NOTICE TO MARINERS No 10 of 2021

Chart Correction – New pontoon near New Flagstone Wharf in the Grand Harbour

Reference is made to BA Charts 177 - Valletta Harbours

Charts Affected: BA Chart 177

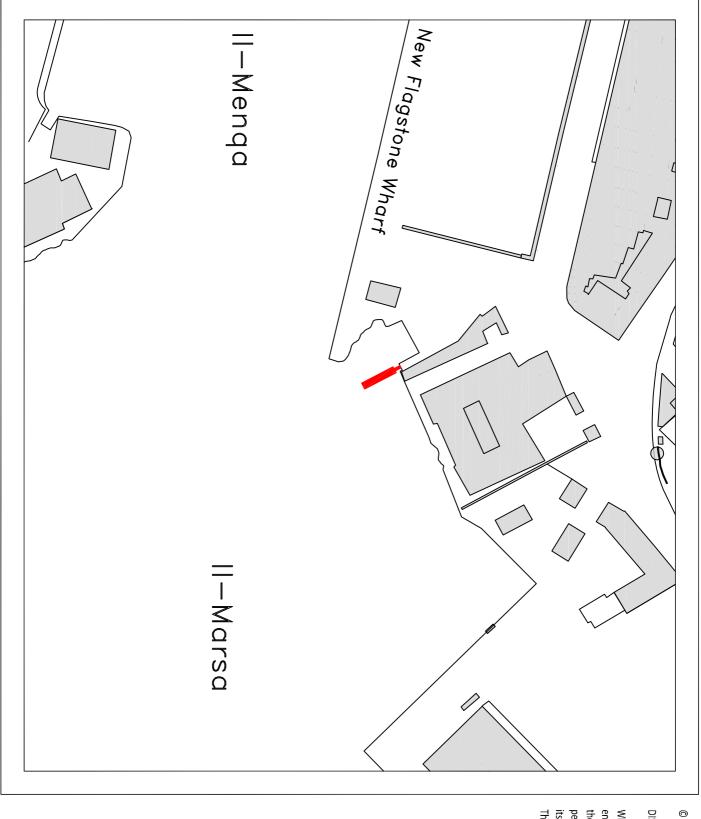
The Ports and Yachting Directorate, Transport Malta notifies Mariners that a new floating pontoon has been established near New Flagstone Wharf in the inner part of II-Port II-Kbir, as shown on attached chart.

Latitude (N)	Longitude (E)
Insert floating pontoon	from	35° 53'.095	014º 30'.014
	to	35° 53'.087	014º 30'.019
